Wetherill Park Waste Transfer Station

*State Significant
Development
Modification Assessment
(SSD 7267 MOD 2)*

April 2019

Figure 3 | Staging Plan

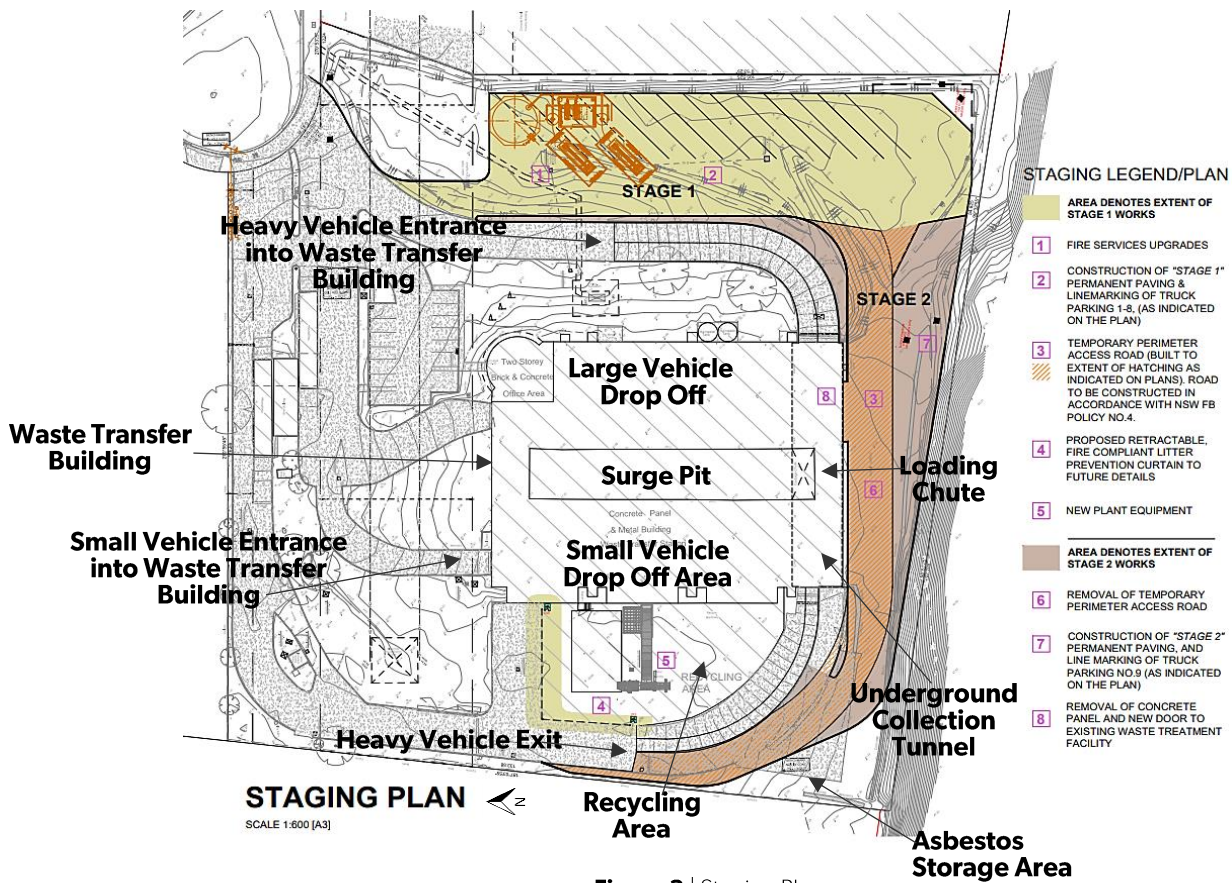
In the interim, the Applicant has proposed to construct a temporary perimeter access road (see **Figure 3**) to gain access to the southern side of the WTS to ensure compliance with Fire and Rescue NSW's (FRNSW) Guidelines for Emergency Vehicle Access Policy Number 4, 2010 (Policy No. 4) and allow emergency vehicles access to the rear of the WTS if needed in the event of a fire.

Once the landslip issues have been resolved and as part of the Stage 2 construction, the Applicant has proposed to construct the permanent access road and install a roller door as approved in SSD 7267 (see **Figure 3** and **Figure 4**).

The upgrade of the fire safety system will require removing four of the twelve heavy vehicle parking spaces to provide adequate area for the temporary parking of FRNSW vehicles in the event of a fire at the WTS, removal of the workshop and construction of additional hard stand for parking and fire service infrastructure. The Applicant proposes to install the additional fire safety system in Stage 1 construction (see **Figure 3** and **Figure 5**).

Figure 6 | Encroachment from the Former Landfill Site on the Southern Boundary of the WTS

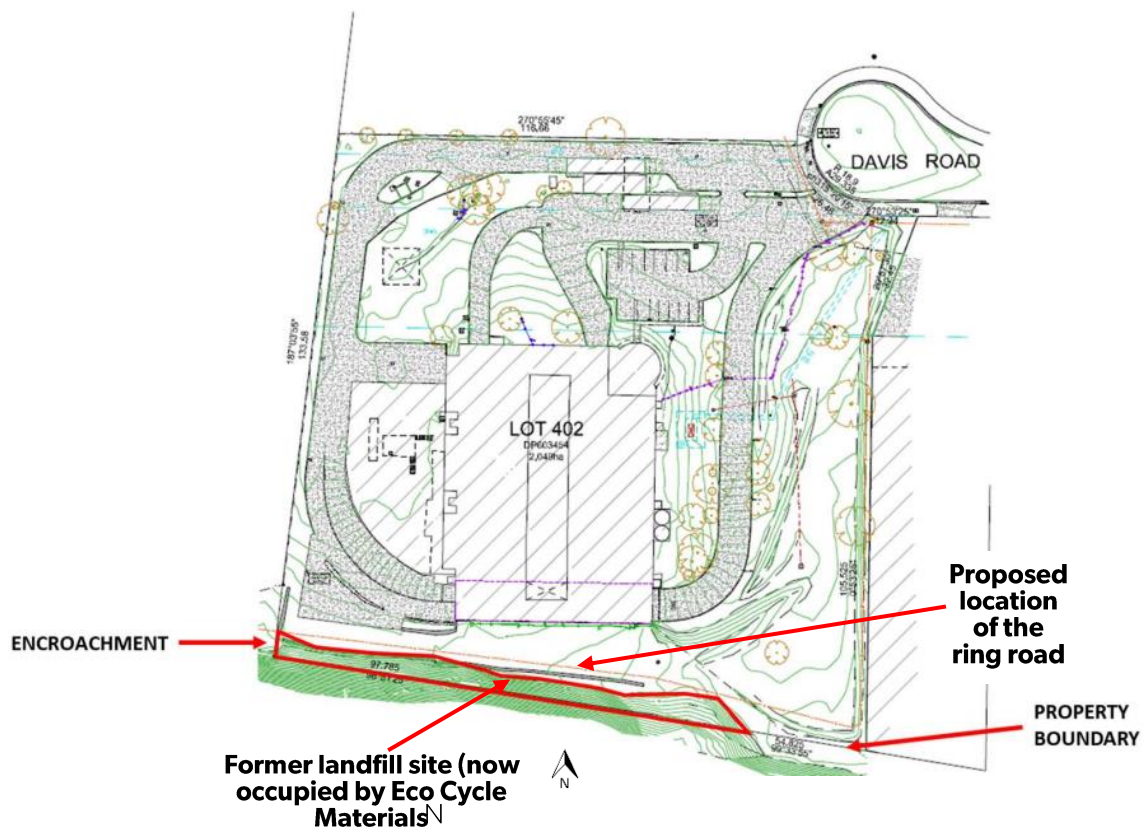
During a recent survey of the WMF, the Applicant identified a landslip from the southern side of the former landfill had encroached onto the Applicant's site. The landslip has prevented the Applicant from completing design works as it obstructs the turning path of heavy vehicles (see **Figure 6**). The Applicant has been in negotiations with the adjacent landowner since January 2018 to remediate a portion of the site impacted by the landslip.
